**RFP Title: Western Johnston High Service Expansion (Site Work) - Contract 2 (Exp. 12/31/24)**

**Addendum #: 2**

**ADDENDUM NO. 2  
FOR  
WESTERN JOHNSTON HIGH SERVICE EXPANSION – (Site Work)  
CONTRACT 2 (Expires 12/31/24) JOHNSTON, RHODE ISLAND  
PROVIDENCE WATER SUPPLY BOARD  
MAY 11, 2023**

SITE PLAN  
 DRAWING NO.: C4.0  
 SHEET NO. 6 OF 45

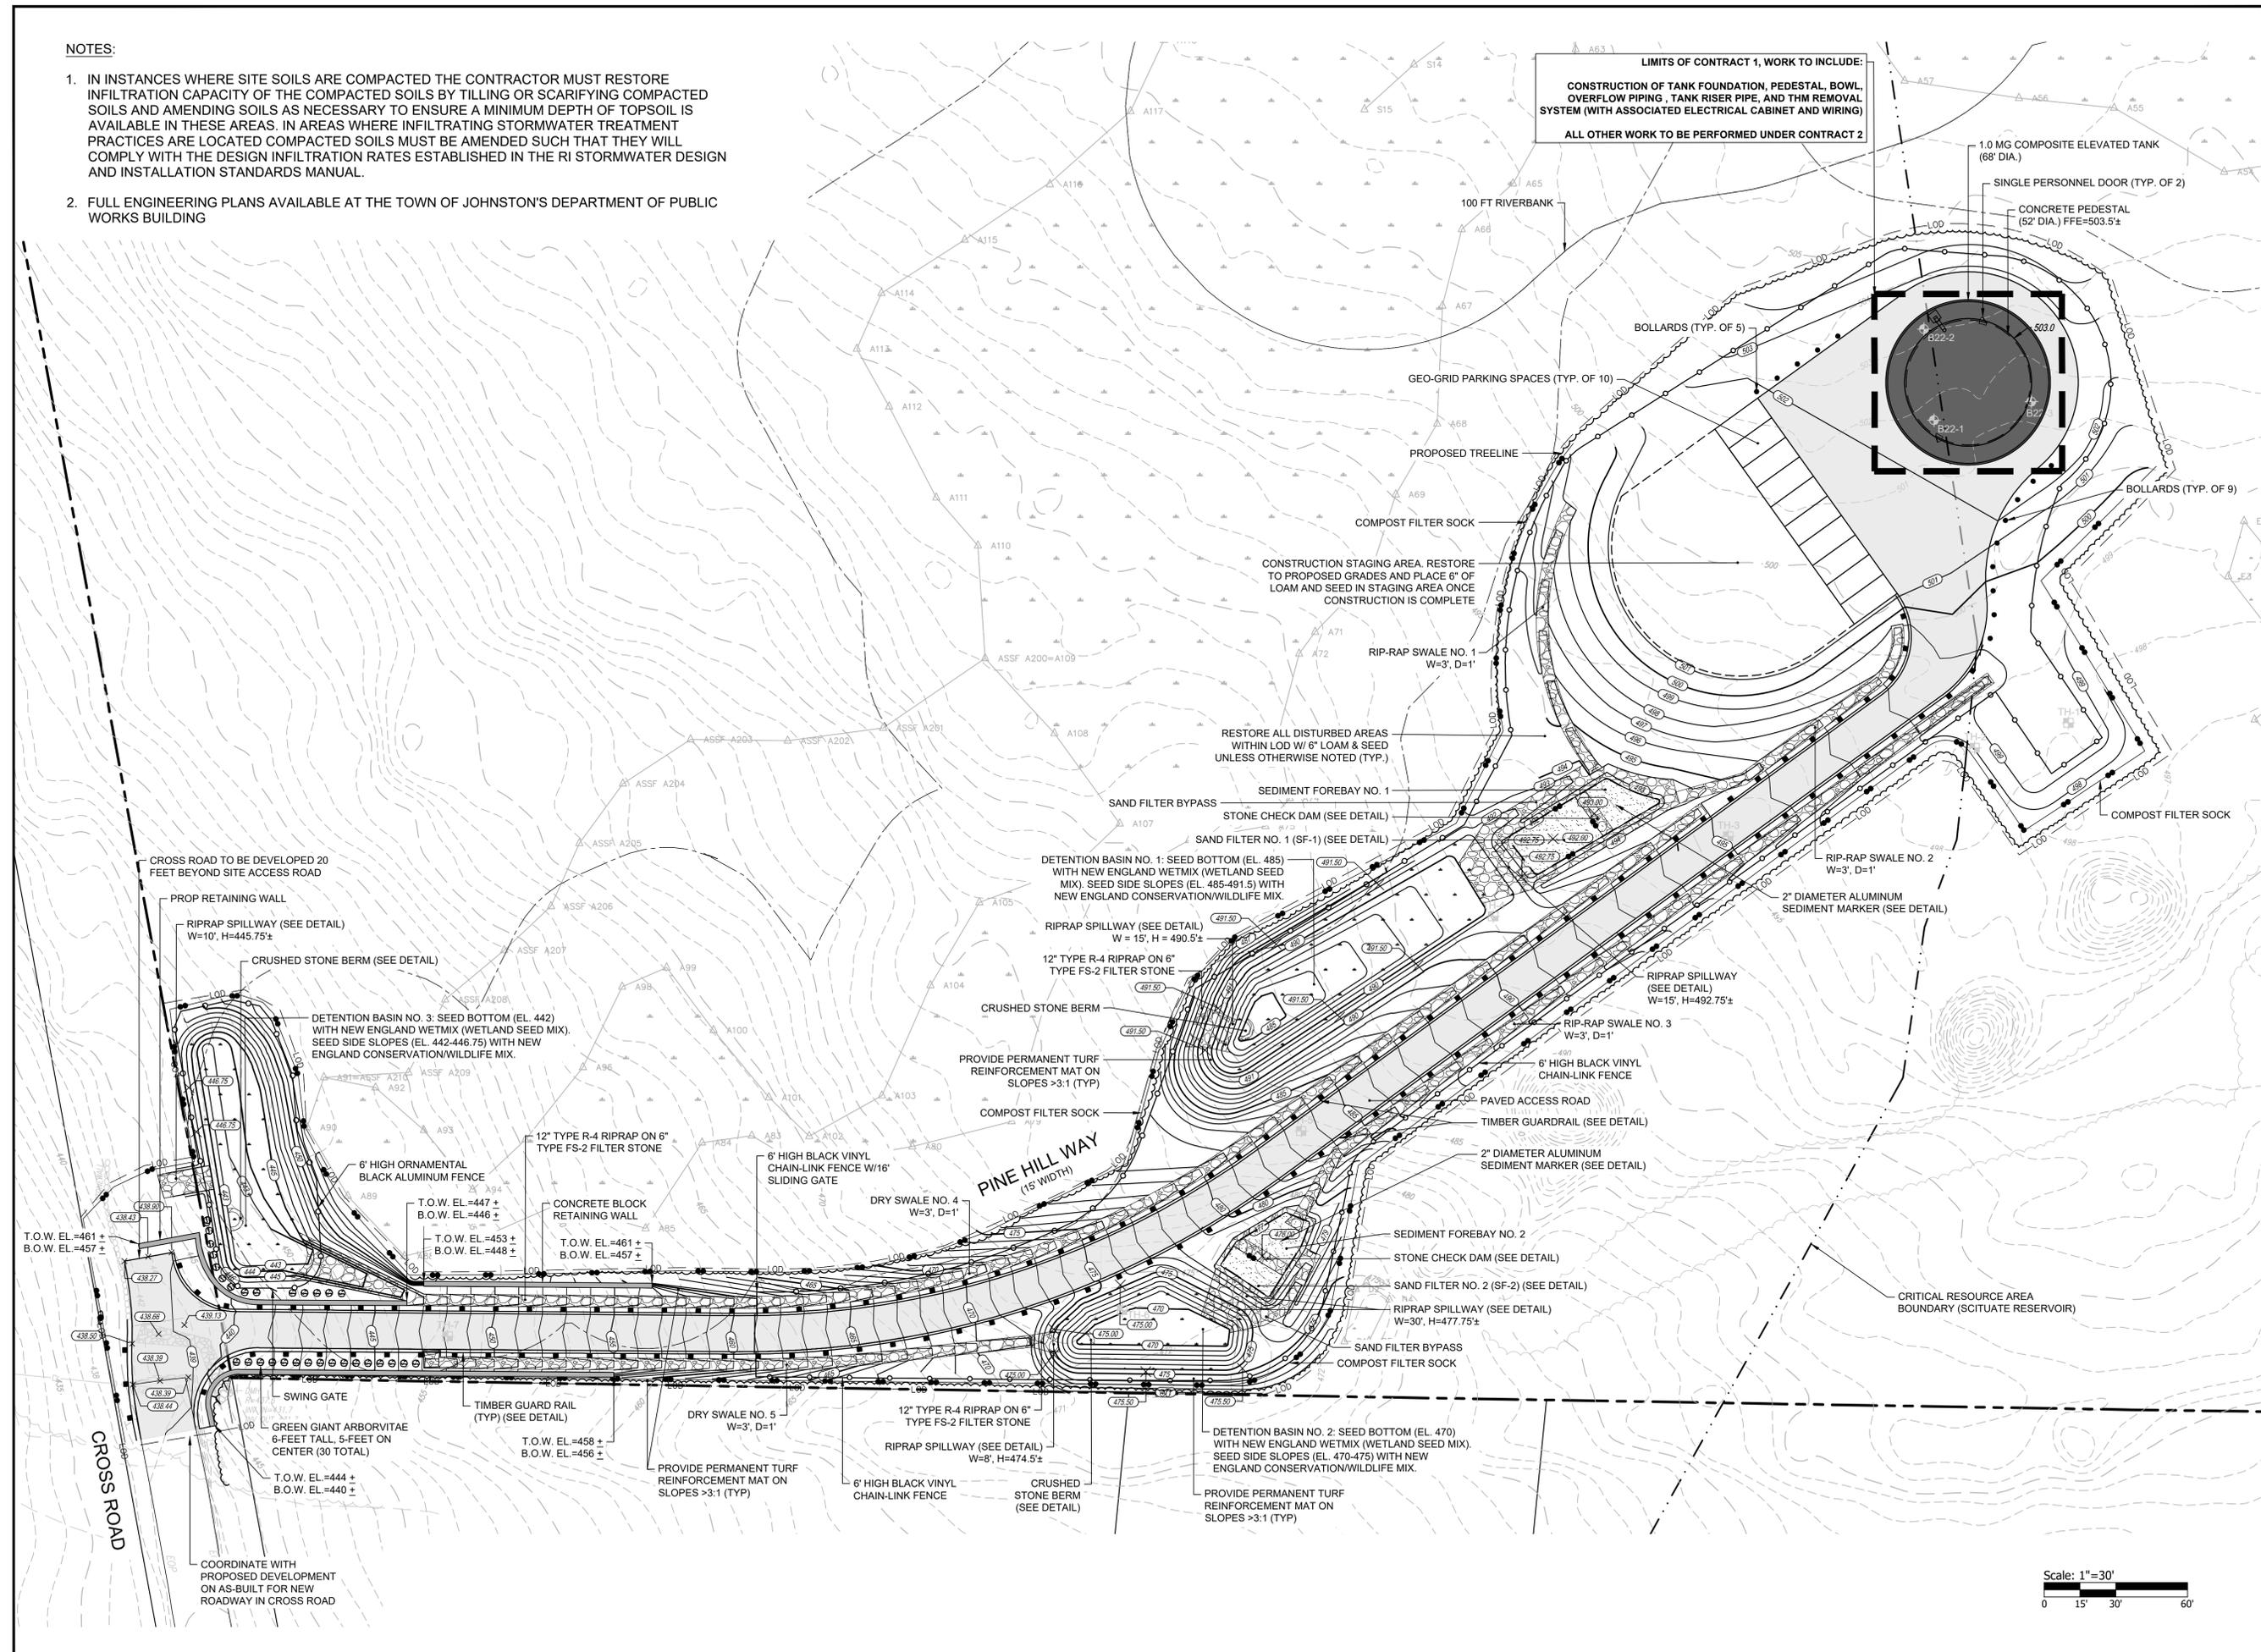
Replace sheet C3.0 in its entirety with Revised Sheet C4.0 – Site Plan (Addendum No. 4). The revised sheet is attached to this addendum.

Please note that the following changes have been made to the sheet:

1. For callouts concerning the 6’ ornamental fence, replace with “6’ high black vinyl chain-link fence;
2. Remove callout “Contractor to remove boulders” from sheet;
3. Add top of wall (TOW) and bottom of wall (BOW) elevations to retaining walls;
4. Remove TP-1 from sheet; and
5. Replace TP-2 with “TH-7”.

- 11. Drawings C4.0 and C7.5 Indicate a requirement for an Ornamental Fence. The specifications (02831) are written around a chain link fence. Please confirm what the fence requirements are for the Project.**

- 14. Drawing C4.0 contains a note indicating that the 6ft ornamental fence is mounted on the Block Retaining wall. However, there doesn't appear to be any retaining wall in the area that the leader arrow points to. Please confirm the limits of ornamental fence that is to be installed on the retaining wall.**

Black vinyl chain-link fence, 6-feet tall.

Note indicating that the 6-foot ornamental fence mounted on the block retaining wall has been deleted. No fencing shall be installed on the retaining walls.

ACCESS ROAD DETAIL  
NOT TO SCALE

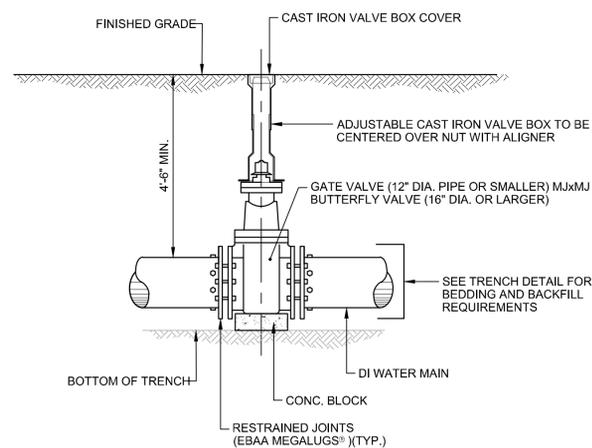
1. Add detail “Typical Section – Unreinforced Retaining Wall”; and
2. Add detail “Access Road Detail”.

- 29. With regard to Plan C7.5 Roadway Section Detail. This detail depicts curbing on both sides of the road and a stone/gravel pathway. The detail does not depict guard rail. Plan C4.0 depicts only guard rail. Is it the intent to have all three elements curbing / guard rail / stone pathway. If this is the case would curbing be granite or precast concrete?**

An Access Road Detail has been added to sheet C7.3 – Details 3.

TYPICAL SECTION - UNREINFORCED RETAINING WALL  
NOT TO SCALE

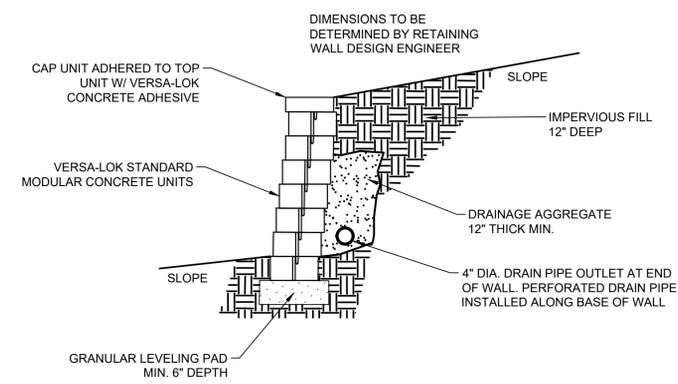
- 13. The proposed details and heights of the proposed retaining walls are unclear. Please provide elevation drawings and sections with proposed grades for each of the proposed retaining walls.**

See revised sheets C4.0 – Site Plan and C.7.6 – Details 6.

TYPICAL SINGLE CANTILEVERED SLIDING GATE  
NOT TO SCALE

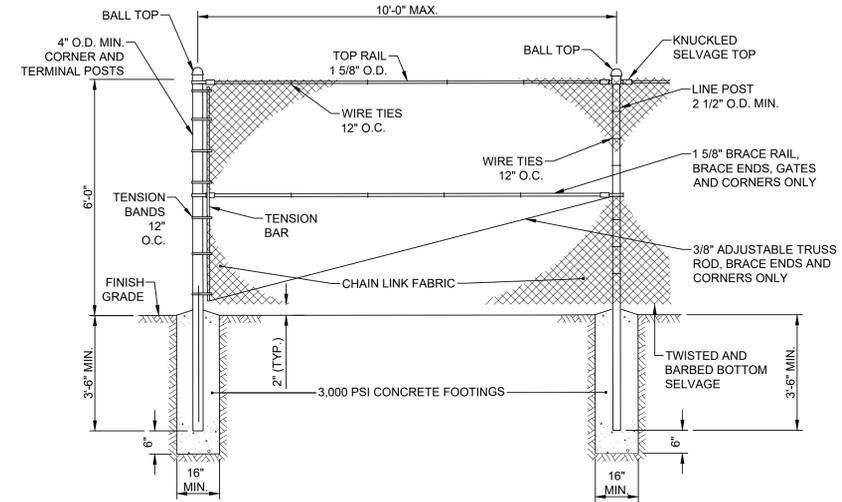
3. Replace Cantilever Gate Detail with “Typical Single Cantilevered Gate Detail”; and
4. Replace Ornamental Fence Detail with “Chainlink Fence Detail”.

- 12. The plans indicate a cantilevered sliding gate. However, the proposed grading in the area of the gate does not appear to allow enough room for when it is in the open position. Please confirm the type of gate desired.**

The cantilevered sliding gate will remain. Grades will be adjusted in this area during construction.

TOWN OF JOHNSTON - TYPICAL STREET CROSS DETAIL  
NOT TO SCALE

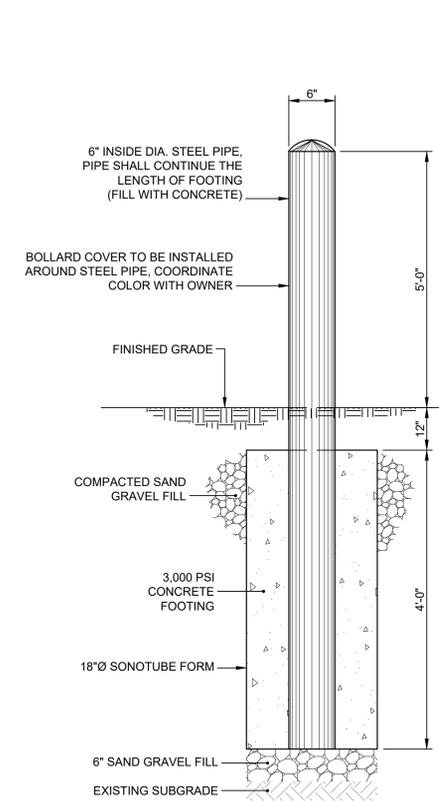
- 24. Geotechnical Report Pg. 15: Table 6.2 Table depicts standard duty paving with a base course of 6" and a subbase course of 8". The Road-way Section on plan C7.5 depicts 6" and 6" respectively. Clarification is requested.**

The roadway section on sheet C7.5 shows the Town of Johnston's typical street detail. This detail should be followed for the extension of the existing Cross Road. Page 15, Table 6.2 should be referenced for the Site's access road construction.

The detail on sheet C7.5 “Town of Johnston – Typical Street Cross Detail” is for the tie-in and continuation of the existing Cross Road. The contractor shall match existing roadway conditions.
